HepcoMotion®

SBD Product Update - Change Notification

SBD20-80 Standard Carriage

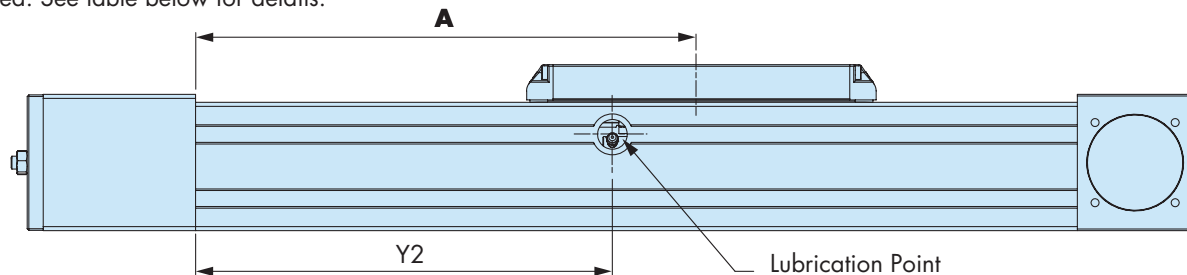
External dimensions of this unit have not changed however the position of the centre of the carriage relative to the lubrication port has altered. See table below for details.

Unit type	A	Y2
SBD 20-80 / SBD 20-80 C1	312	260

SBD20-80-B2 Long Carriage

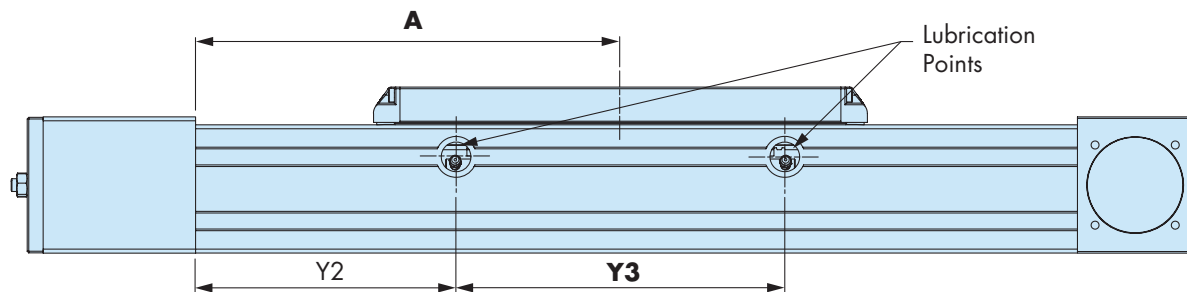
The dimensions for the position of the two lubrication ports Y2 and Y3 has been altered, See table below for details.

Unit type	A	Y2	Y3
SBD 20-80 B2 / SBD 20-80 C1 B2	258.5	162.5	192.5
